Consultants Advice Notice

Project:	Ardex Australia SEPP 33	Ref No.:	RCE-21117
From:	Lucy Jimenez	Date:	9/02/2022
	Steve Sylvester	Revision:	0
Attention	Company	Email	
To:	Cameron Gray	Willow Tree Planning	cgray@willtp.com.au
RE: ARDEX Warehouse and Manufacturing Facility (SSD-25725029)

1.0 Response to Comments from DPIE

Figure 1-1: Proposed Site Layout

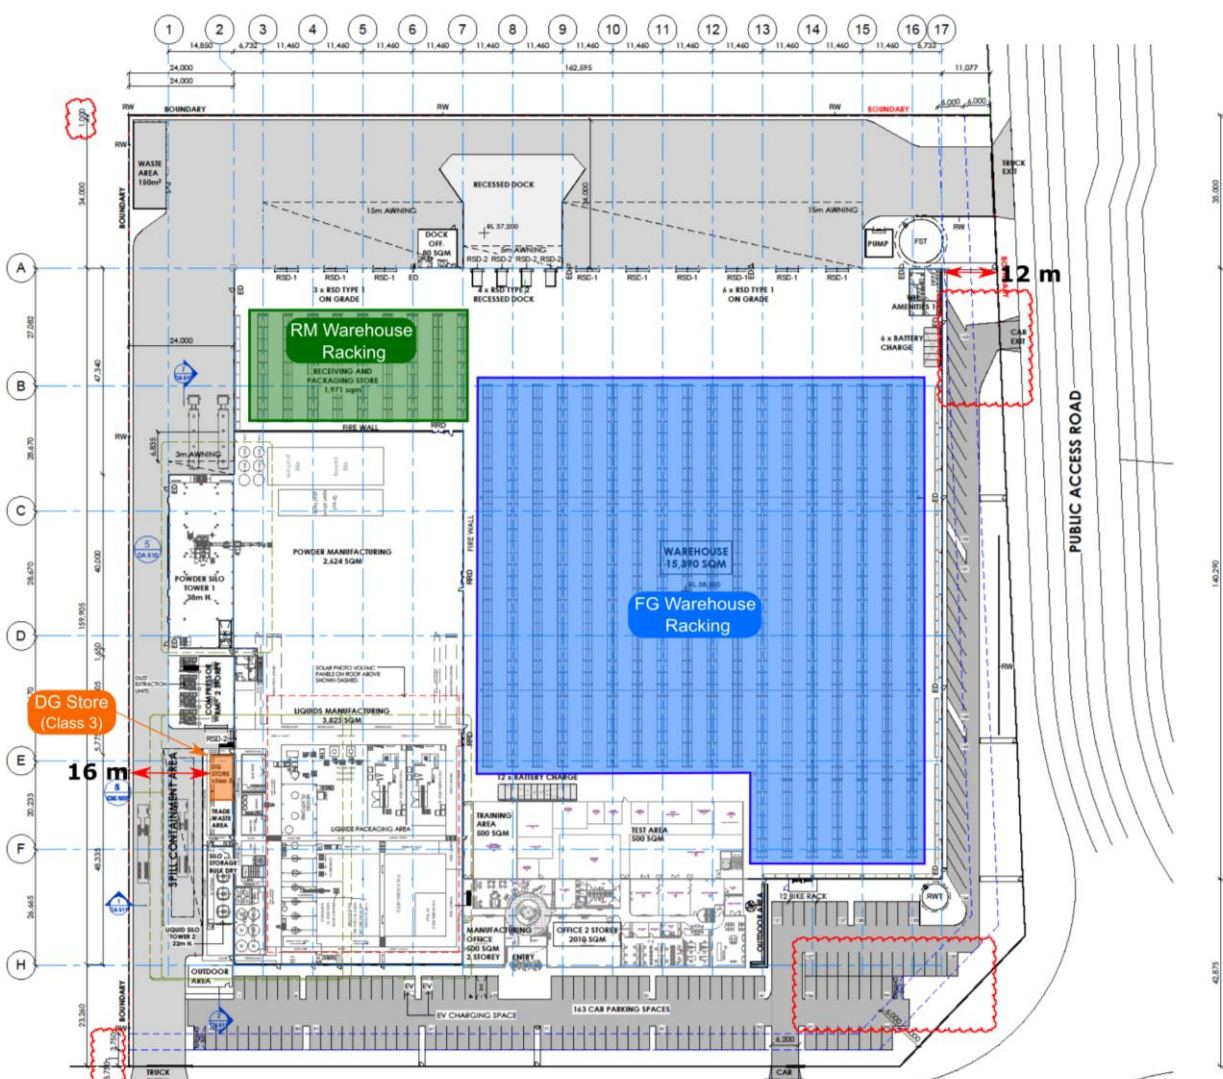
No.	Comment	Response
1.c.	The Department seeks clarification on whether any of the Class 9 or other hazardous materials are defined as a combustible liquid C1 (as classified by AS 1940) and stored at the proposed development. We request the Applicant provide any quantity of combustible liquid C1 to be stored at the proposed development. As per “Applying SEPP33”, page 16, where combustible liquids C1 are kept within a store with flammable liquids they are treated as DG Class 3 PGIII and must be added to the flammable liquids’ quantity when undertaking the preliminary risk screening	A review of the SDS of the Class 9 DGs indicates that no combustible liquids (C1) will be stored.
2	The proposed development will incorporate an office space. The Department highlights that these offices would be classified as an on-site protected place by Australian Standards for the handling of DGs. The Department seeks information on separation of the warehousing areas (containing DGs) to the offices, noting the requirements of Australian Standards for storage and handling DGs.	<p>DGs will be stored in the Class 3 Store, in the Raw Materials (RM) warehouse and in the Finished Goods (FG) warehouse. The required separation distances are as follows:</p> <ul style="list-style-type: none"> • <u>Class 3 DG Store</u>: 10 m separation is required as per Table 4.1 of AS 1940–2017. • <u>FG/RM Warehouse</u>: As only manufactured products in retail-size packages are stored in this area, it has been classified as a retail distribution centre (RDC) under AS/NZS 3833:2008. RDCs do not have specified separation distances to protected places. However, as per Clause 3.2.5(e) of the standard, the walls of the warehouse adjacent to offices shall be constructed of fire walls with an FRL of 60/60/60. <p>As shown in Figure 1-1, these separation distances have been met.</p>
